Customer	: CU-DAR001 Dart Helicopters Services	Drawing Name	: HELI UTILITY BASKET LH/RH 350/355
Job Number	: 33265		
Estimate Number	: 10208		
P.O. Number	: <i>N/A</i>	Part Number	: D350607043
This Issue	: 6/29/2007 S.O. No. : <i>N/A</i>	Drawing Number	: D350-607 REV F P7-9
Prsht Rev.	: NC	Project Number	: N/A
First Issue	: <i>N/A</i> Type : LARGE FAB ASSY	Drawing Revision	: F
Previous Run	: 33001	Material	: <i>N/A</i>
Written By	: <i>[Signature]</i>	Due Date	: 7/30/2007 Qty: 1 Um: Each
Checked & Approved By	: <i>[Signature]</i>		
Comment	: Est Rev:E as Per DSI9318 06-01-24 JLM

DESIGN <i>CP</i>	DRAWN BY <i>CP</i>	DART AEROSPACE LTD HAWKESBURY, ONTARIO, CANADA	
CHECKED <i>[Signature]</i>	APPROVED <i>[Signature]</i>	DRAWING NO. DSI 9318	REV. A SHEET 1 OF 1
DATE 06.01.06		TITLE WASHER ADDITION	SCALE NTS
A	06.01.06	NEW ISSUE

DART SERVICE INSTRUCTION

TO AMEND INSTALLATION INSTRUCTIONS D350-607 REV. F

The corrected bolt stackup from Figure 5 of installation instructions D350-607 Rev. F is given below:

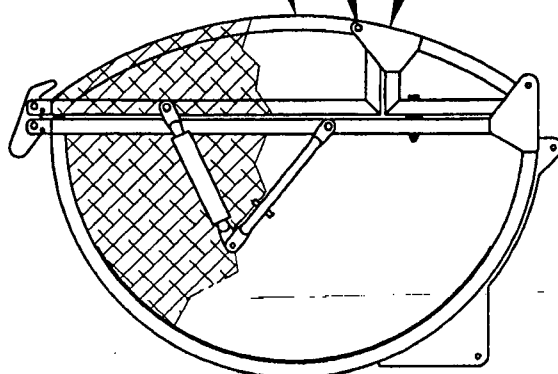
To reduce the possibility of damaging the finish, a **NAS1515H4** washer (2 places) has been added between the hinge plate and basket frame on the **D350-607-043/-047 Heli-Utility-Basket**.

AN4-13A BOLT (1)
AN960JD416 WASHER (1)
HINGE PLATE (REF)
NAS1515H4 WASHER (1)
BASKET FRAME (REF)
AN960JD416 WASHER (1)
MS21042L4 NUT (1)
(2 PLACES)
